## **Access Compliance Report Public Rights-of-Way** (Curb Ramps)

Intersection ID: 10012995 Main Street: IVEY\_DR Cross Street: N/A Location:

Overall Compliance: No Severity Score: 21.25 ADA ID: A71AFBDA529D Ramp Type: Perp Initial Pass/Fail: Fail

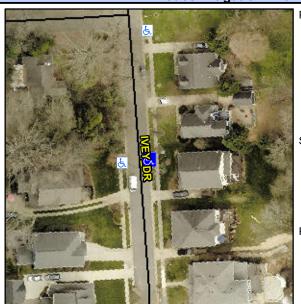
Field Measurements/Component Compliance						
Comp	liance Description	Data	Comp	liance Description	Data	
N/A	Ramp Length (in)	46.5	Yes	Ramp Slope (%)	5.9	
No	Ramp Width (in)	46.5	No	Ramp XSlope (%)	6.2	
N/A	Flare Type LT	N/A	N/A	Flare Type RT	N/A	
N/A	Flare Slope LT (%)	N/A	N/A	Flare Slope RT (%)	N/A	
N/A	Flare Traversable LT?	N/A	N/A	Flare Traversable RT?	N/A	
N/A	Landing Length (in)	N/A	N/A	DWS Provided?	N/A	
N/A	Landing Width (in)	N/A	N/A	DWS Contrast?	N/A	
N/A	Landing Slope (%)	N/A	N/A	DWS Length (in)	N/A	
N/A	Landing X Slope (%)	N/A	N/A	DWS Full Width?	N/A	
N/A	Landing Curb? (Y/N)	N/A	N/A	DWS Offset (in)	N/A	
N/A	Shared Landing?	N/A				
N/A	Gutter Ponding?	N/A	N/A	Gutter Slope (%)	N/A	
N/A	Gutter Lip Ht (in)	N/A	N/A	Gutter X Slope (%)	N/A	
N/A	Painted X Walk1?	No	N/A	Painted X Walk2?	N/A	
	X Walk 1 Direction	To W		X Walk 2 Direction	N/A	
N/A	X Walk 1 Width (in)	N/A	N/A	X Walk 2 Width (in)	N/A	
	X Walk 1 Slope (%)	3.3		X Walk 2 Slope (%)	N/A

X Walk 1 X Slope (%)	7.0		X Walk 2 X Slope (%)	N/A	
N/A	Ramp inside XWalk1?	N/A	N/A	Ramp inside XWalk2?	N/A	
	Road Slope (%)	N/A	N/A	Clear Space?	N/A	
	Road X Slope (%)	N/A	N/A	Clear Space to XWalk (in)	N/A	
N/A	Any Obstructions?	N/A	N/A	Storm Grate/Utility Hazard?	N/A	
	Obstruction Type			Storm Grate/Utility Type		
		N/A			N/A	
			Yes	Surface Condition? (G/P)	Good

Possible Solutions:	<u>c</u>
Remove & Replace Entire Ramp.	
·	N
	N
	N
	N
	N
Surveyor Notes:	N
N/A	N
	N
	N
	N
PROW/ADA:	N
Not Found, R304.5.1, R304.5.3	N
	N
	N
	N
